Edgecore ECW5410-L Release v3.45.0000

Document # Edgecore_ECW5410-L_v3.45.0000_1.13-1.9700.2.3

Enhancement from v3.43.00_1.9-1.9293.2.33

1.1 Port Configuration

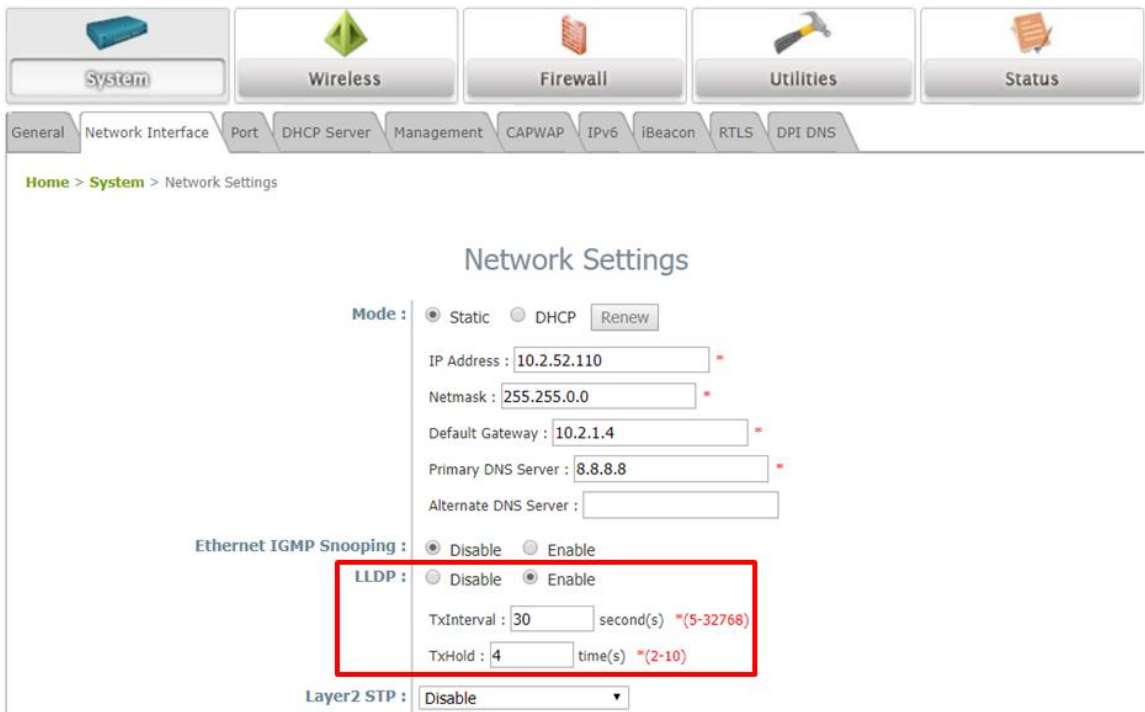
Add Port Configuration page in System for configuring the VLAN ID to specific port.
